File SUP-1995-136

Project Name: Fellowship of Excitement

## **Fellowship of Excitement Review of Traffic Study Revised 10-13-95**

**Fellowship of Excitement**  
**Review of Traffic Study Revised 10-13-95**  
**Review of Traffic Study Submitted 11-27-95**

FIGURE 2

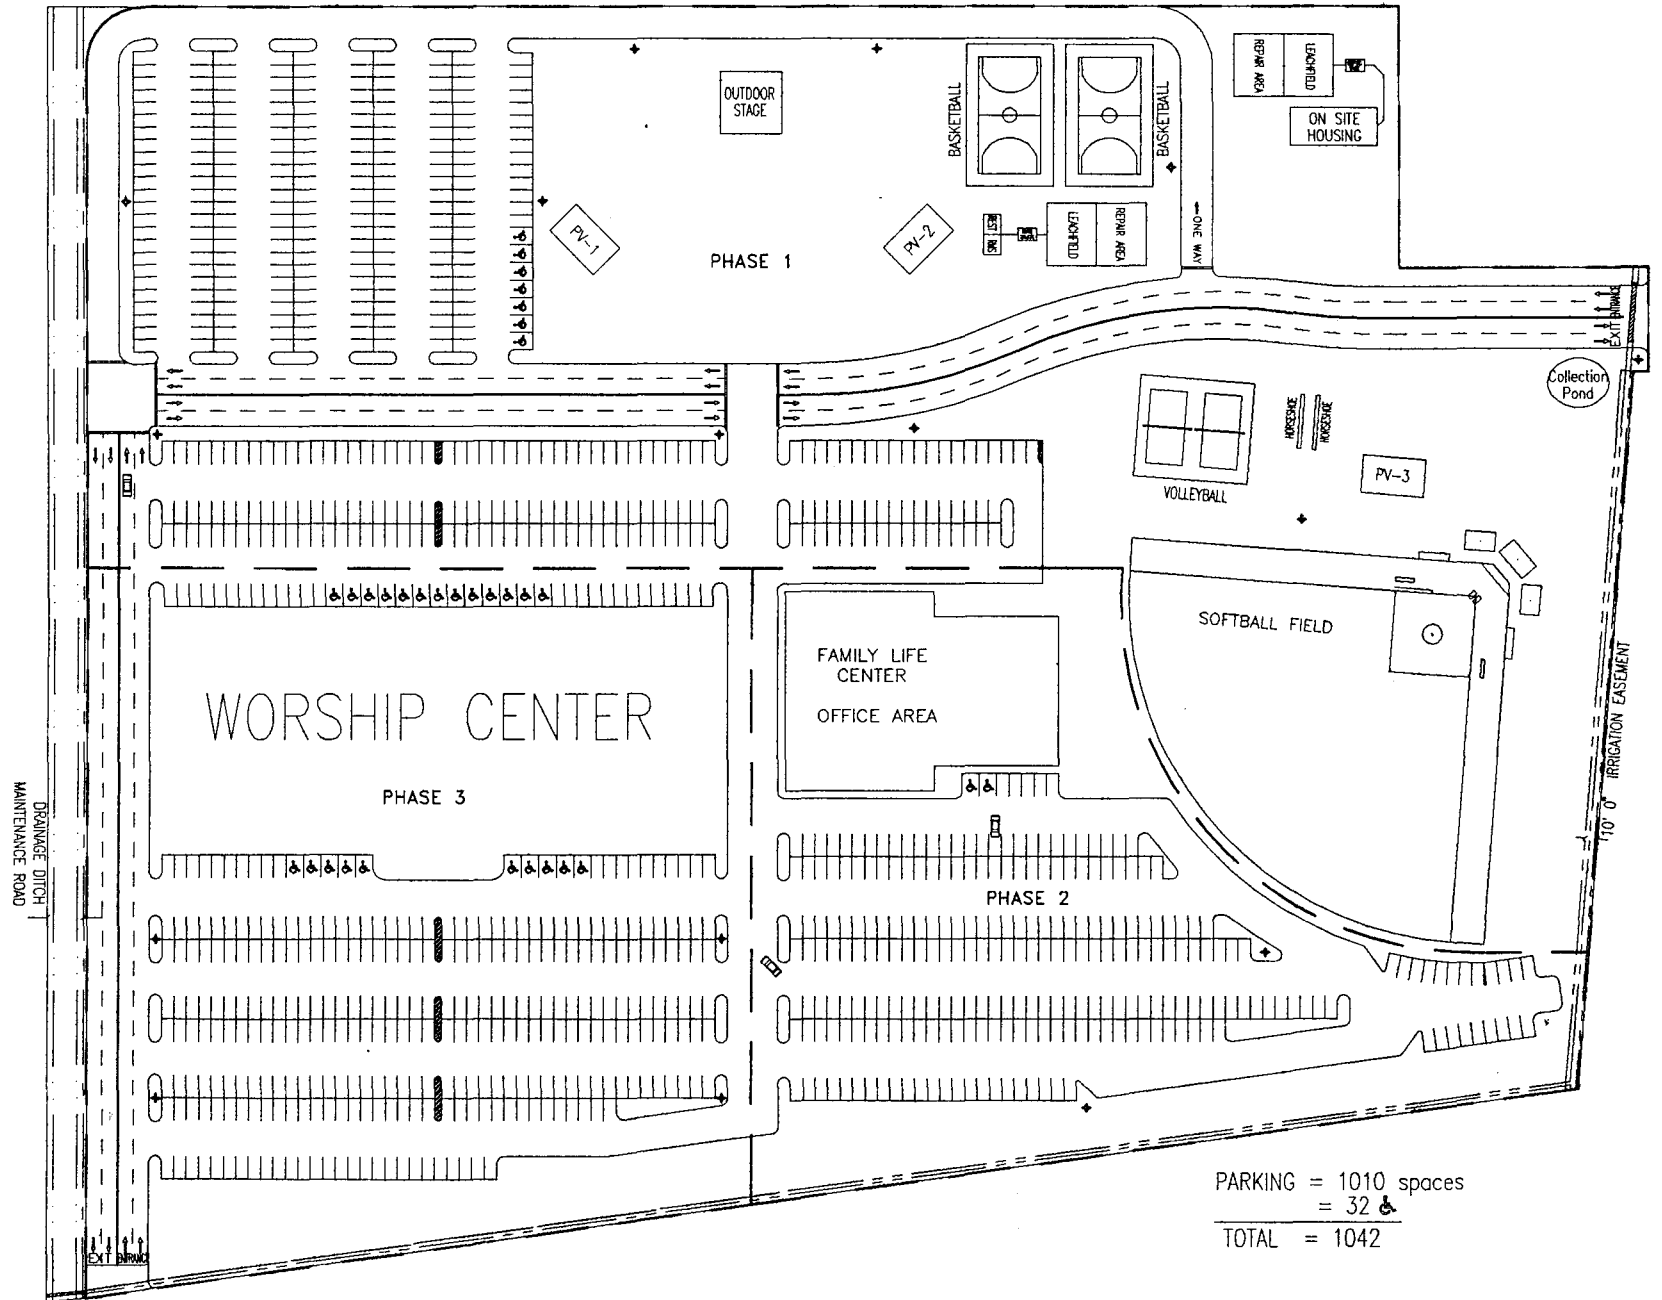
2. The Uses and Parking Table is good. Please show when during the week each use is anticipated to occur. It may be possible to share parking, rather than provide excessive parking and paved area.

2. *The Uses and Parking Table is good. Please show when during the week each use is anticipated to occur. It may be possible to share parking, rather than provide*

*2. The Uses and Parking Table is good. Please show when during the week each use is anticipated to occur. It may be possible to share parking, rather than provide excessive parking and paved area.*

Complete trip information has been provided, and the number of actual parking spaces can be addressed with site plan review by staff.

SUNDAY AM PEAK  
TOTAL BUILT-OUT  
VOLUMES  
FIGURE 7A

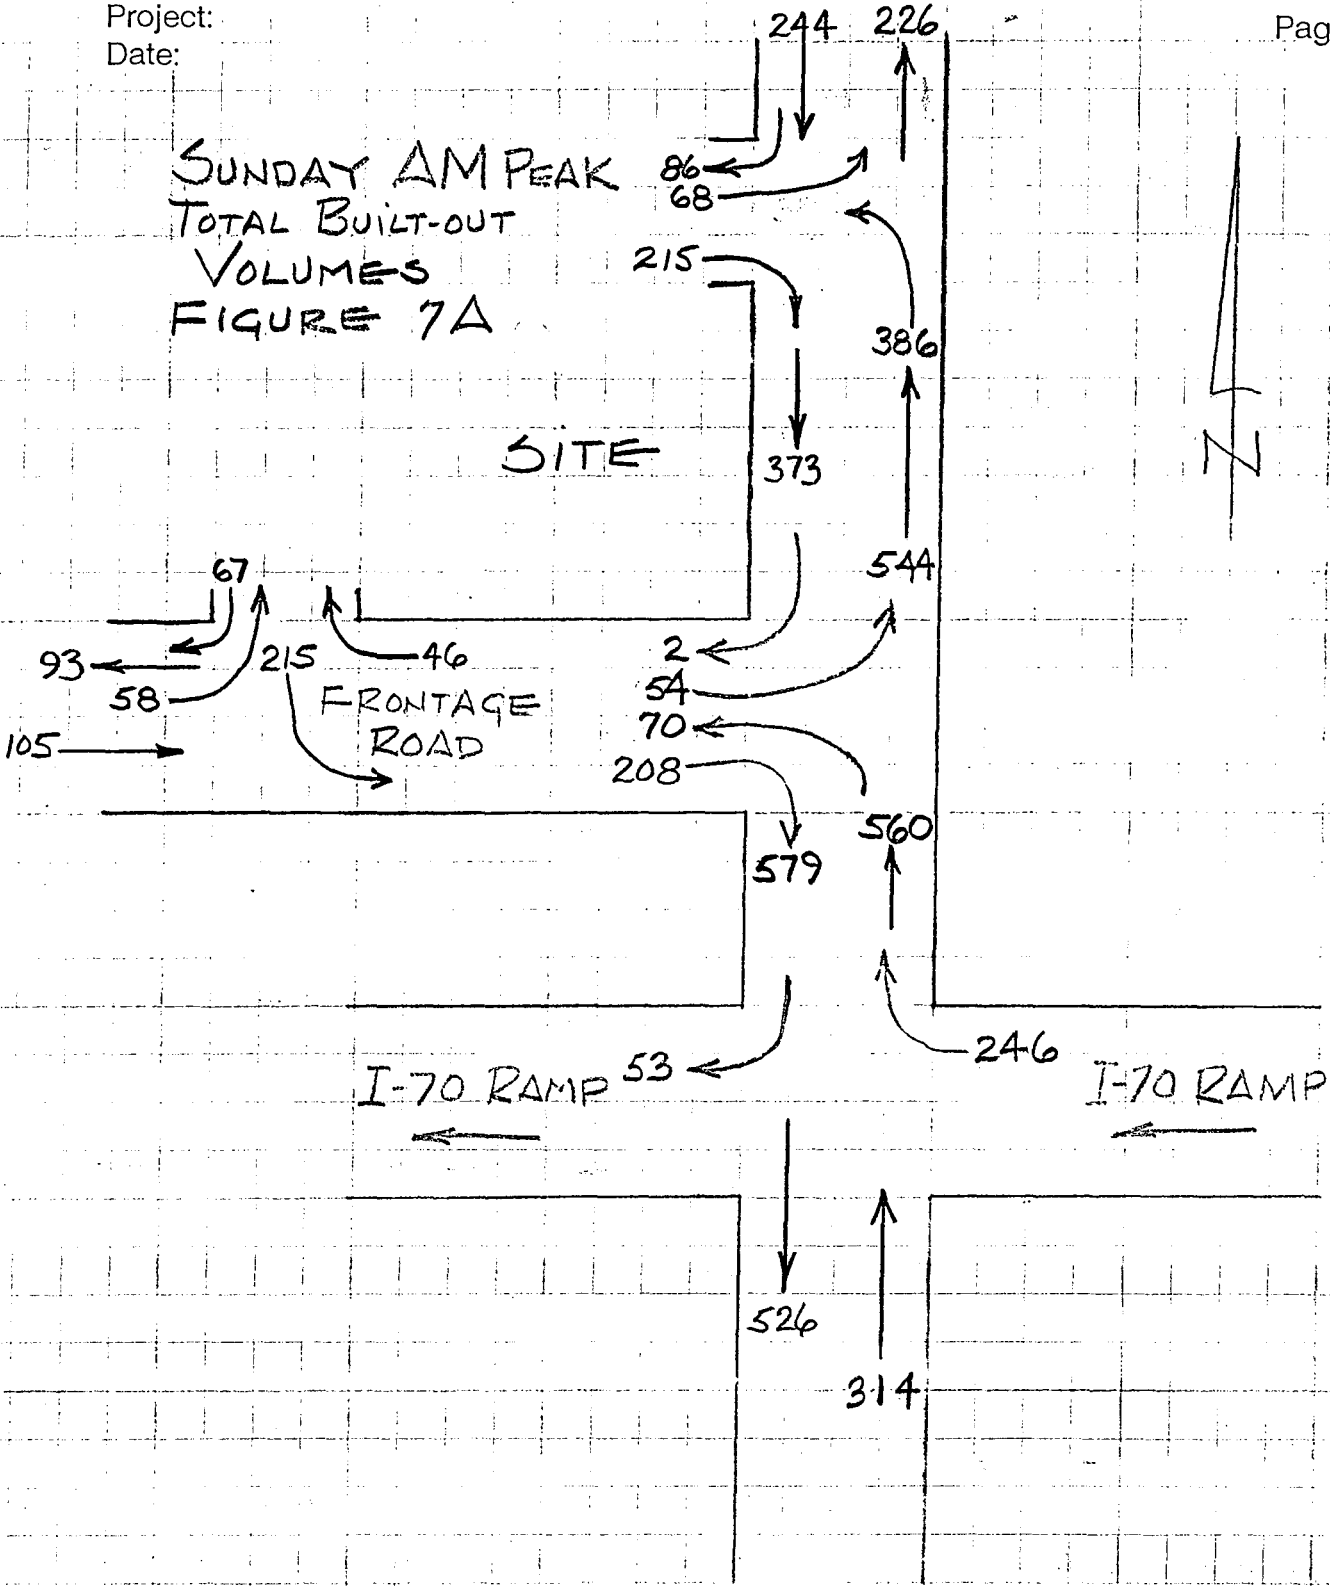
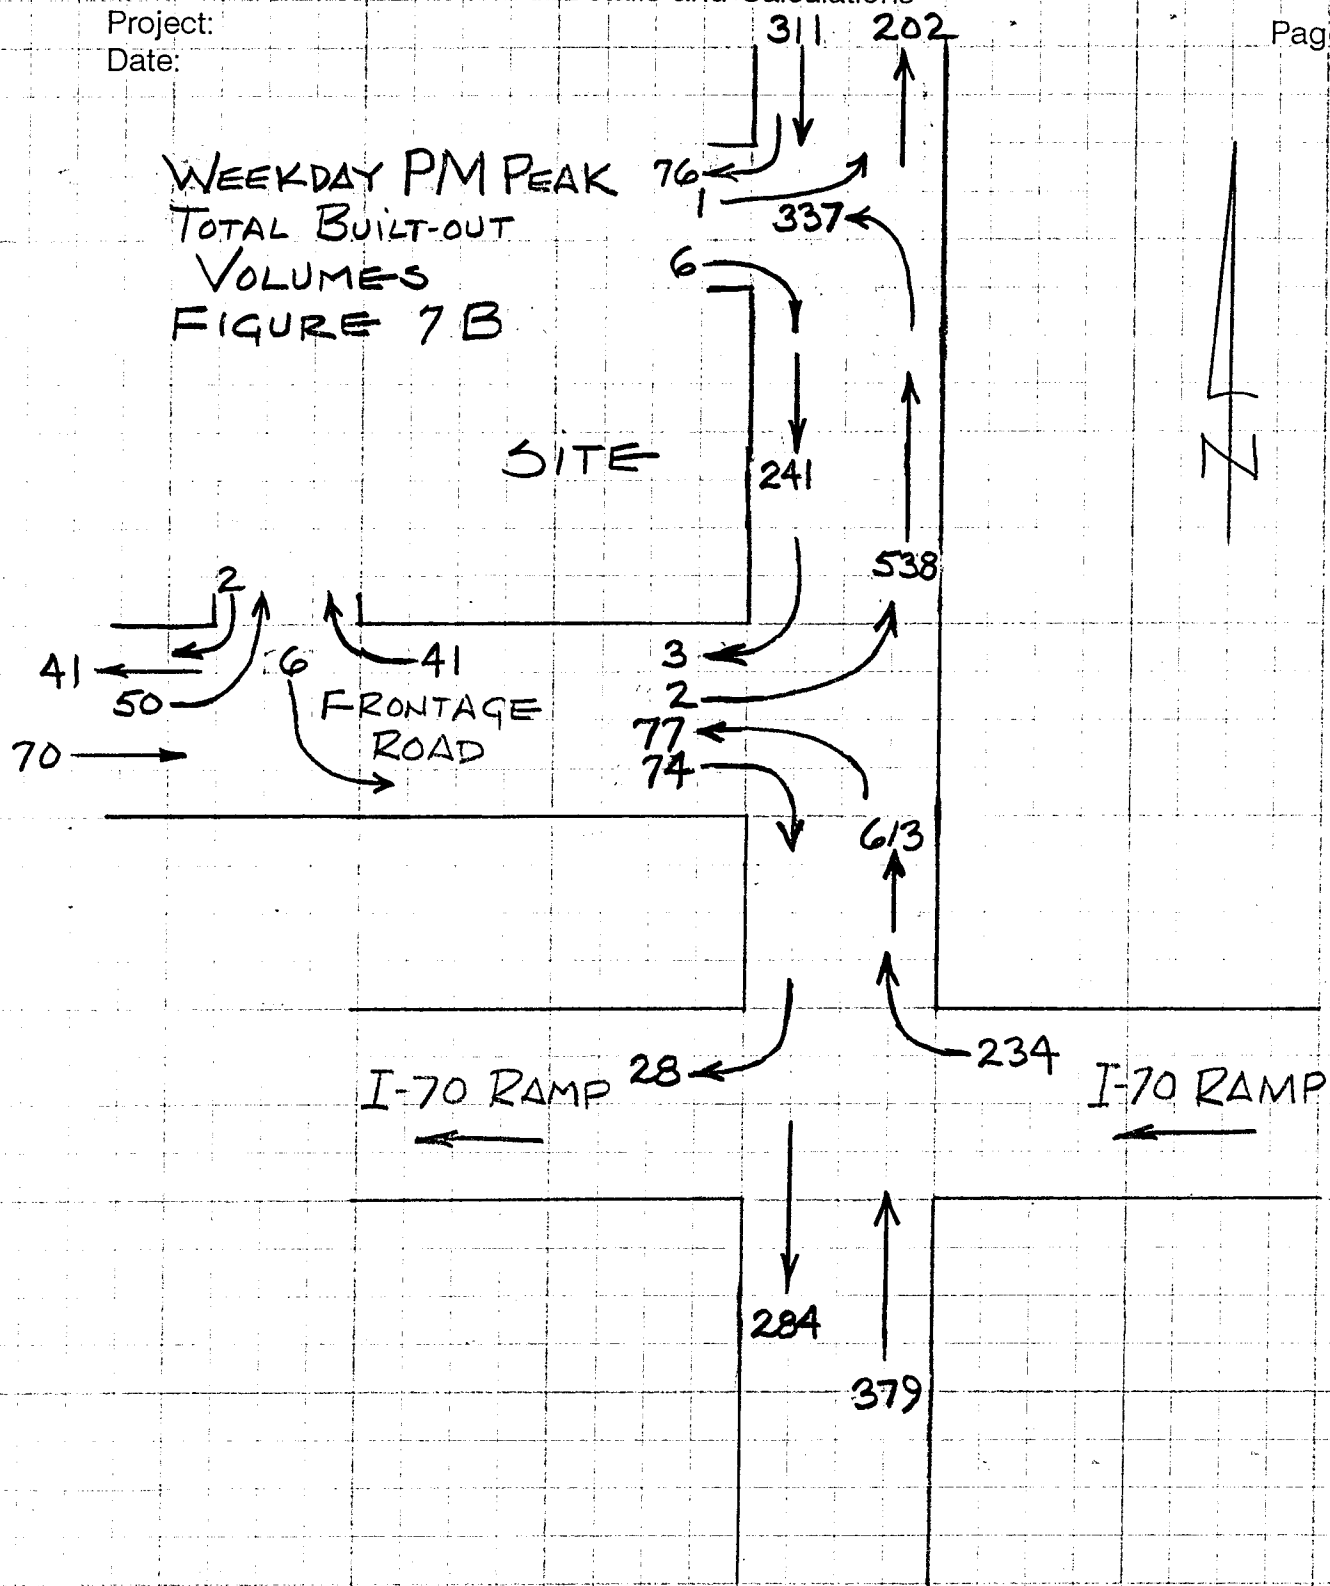
3. The generated traffic does not appear to be added correctly to the existing traffic in Figure 7. Attached is what I came up with based on the numbers provided. The analysis needs to be done on the corrected numbers and I think will produce very different results.

*3. The generated traffic does not appear to be added correctly to the existing traffic in Figure 7. Attached is what I came up with based on the numbers provided. The analysis needs to be done on corrected numbers and I think will produce different results.*

*3. The generated traffic does not appear to be added correctly to the existing traffic in Figure 7. Attached is what I came up with based on the numbers provided. The analysis needs to be done on corrected numbers and I think will produce different results.*
